SPRINGS AT WATERVIEW
PRELIMINARY and FINAL DRAINAGE REPORT
EL PASO COUNTY, COLORADO

September 24, 2017

PROJECT NO.16-01

PCD No. SF-16-017

Type of Inlet — Inlet Type = CDOT TYPE D (Parallel)

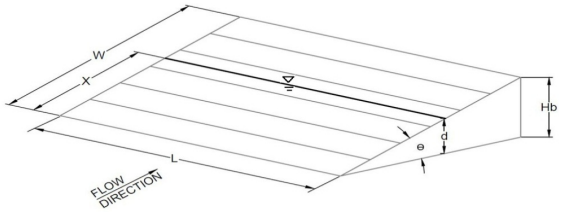
Provide construction details of the inlet in the construction plans. The length of the box does not appear to be sufficient for the pipe going in/out of the inlet. Similar comment applies to DP 43
